intel[®] Action Alert

AA-0748-1

Intel[®] Server Board SE7520JR2 DDR2 MCH VR Circuit Component Failure

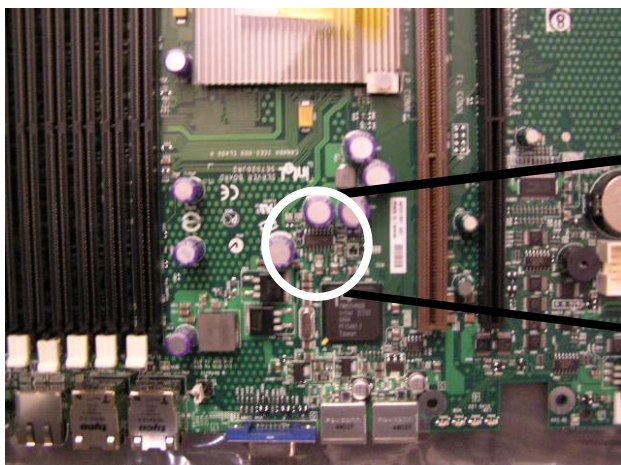
To identify a SE7520JR2 DDR2 board susceptible to this issue, locate the L6910 VR controller chip at board location U6C1 as shown below. **Boards that have a VR controller chip with a white dot "•" silk-screened after the L6910 part number ARE SUSCEPTIBLE to this issue and should NOT be used.**

Boards that have a L6910 VR controller chip with no dot are not susceptible to this issue and can be used.

dot "•"

The L6910 VR Chip is best seen with back edge closest to the person performing the screen. When board is placed as described, chip orientation as shown above is correct.

Customers should screen all existing SE7520JR2 DDR2 product (boards and systems) **that have serial number date codes prior to those noted above** for the following board identifier. Boards found with the identifier should be returned to Intel for immediate replacement.
